OTIS - MACHINE BRAKE SWITCHES

LEIA Product Warning

Machine Brake Switches

Ref: 002	
Page :	1/9
ISSUE	UPDATE
07/09/2010

3.8.1 SPRING ADJUSTMENT (Fig. 3)

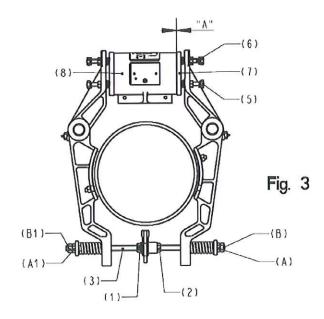
The brake is a TRA200 type supplied with a 125VDC coil, with options of 48V or 60V. The brake has two arms, each with a none asbestos brake lining bonded to a steel plate, assembled to the arm with bolts. Each arm is pivoted with compression springs mounted on a common rod.

The brake spring should be adjusted at jobsite in function of the parameters to be obtained (confort, stopping accuracy, code requirements, etc....)

Spring adjustement procedure:

- 1.- With an empty car, buffer the counterweight.
- 2.- Switch off the mains isolator.
- 3.- Note the length of each spring.

- 4.- Release nuts (1), (2), (B), (B1)
- 5.- Carry the external nut (B) (sheave side) at the end of bar (3) and fastening the bar (3) thight against the nut (A).
- 6.- Fastening blacked nuts (A) and (B) release/tight the nut (A1) to dicrease/increase spring force until obtain the desired.
- 7.- Being careful that previous length is not modified, fasten the nut (A1) and tight against it the nut (B1).
- 8.- Tight two nuts (1), (2) at the same time, against the central lug, taking care that bar (3) does not move axially.

18ATF MACHINE BRAKE SWITCH ADJUSTMENT INSTRUCTIONS (TAA5300CV)

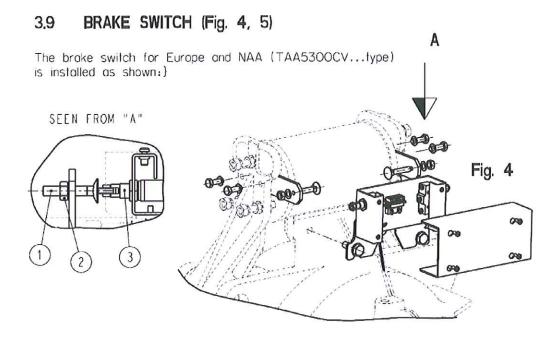
The brake switch should be adjusted as follow:

- 1.- Release nut (2)
- Turn the actuating screw (1) till the switch (3) contact is activated (a click sound)
- Turn the actuating screw (1) in the opposite direction just till the switch contact is deactivated (another click sounds)
- 4.- Turn the actuating screw (1) an additional half turn in the same direction indicated in point 3 (the switch contact remains deactivated)
- 5.- Tighten nut (2) holding the screw (1) in the same position.

29CT Machine

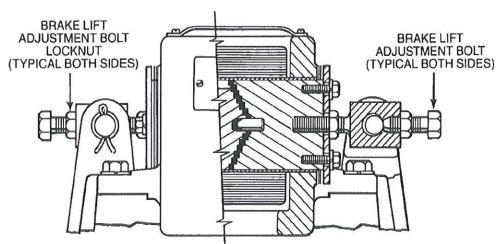
- 1. Run car and verify brake shoes clear brake pulley when brake is fully picked.
- 2. Adjust brake pick by turning the adjusting bolt on the brake cores to obtain .003" .006" of clearance between brake shoe and drum.
- Listen to brake as car is running on inspection. Turn adjusting bolt out until you hear a slight ticking noise of brake shoe touching drum.
- 4. Turn adjusting bolt in till noise stops.
- Turn adjusting bolt in another 1/4 turn, This should provide sufficient clearance of brake to drum.

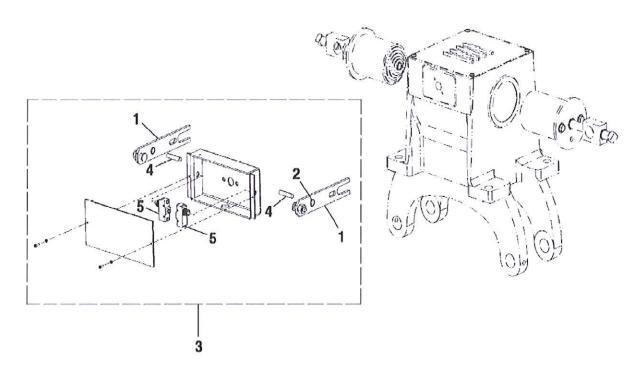
- 6. In order to adjust the brake switches properly, run the car on Inspection and adjust the set bolts so that the BSR relay drops with the brakes up at their fully picked positions. Tighten lock nuts and verify operation.
- 7. Tighten the locking nuts on the brake adjusting bolts. Run the car and verify that the brake shoes do not drag the drum.

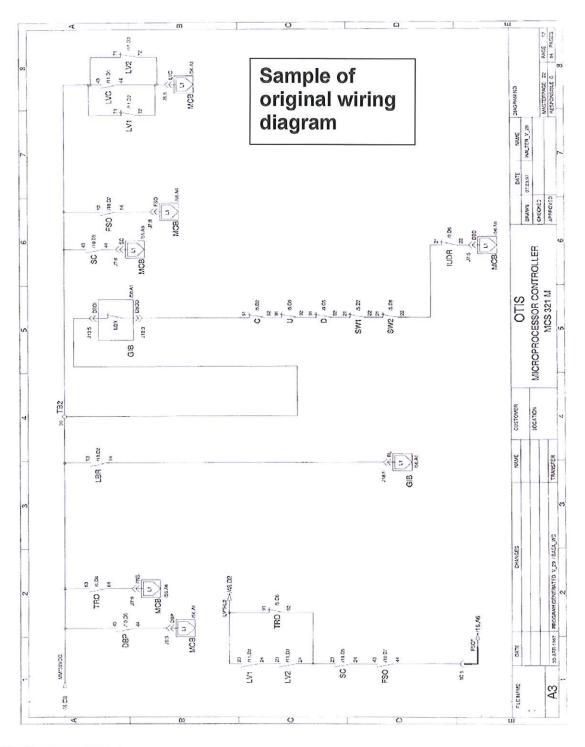
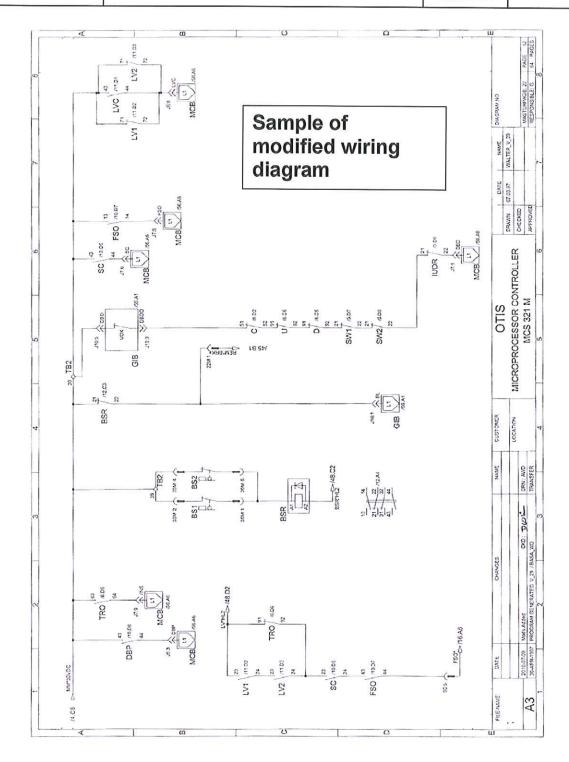
- 6. Fit a new BSR relay (GAA613HE1) in the control panel and connect as per wiring diagram, (See examples of wiring diagrams below).
- 7. Route a new double insulated, three core 0.75mm stranded cable from the controller to the brake terminal block utilise existing trunking and conduit where possible.

- 8. Wire as shown in the wiring diagram below, a new female five pin WAGO plug will be required (FAA176E5); the centre pin should be wired to HL1 for an earth connection.

- 9. Verify all wiring modifications have been applied to the wiring diagrams.
- 10. The electrical drawings will require marking up to reflect the changes made.
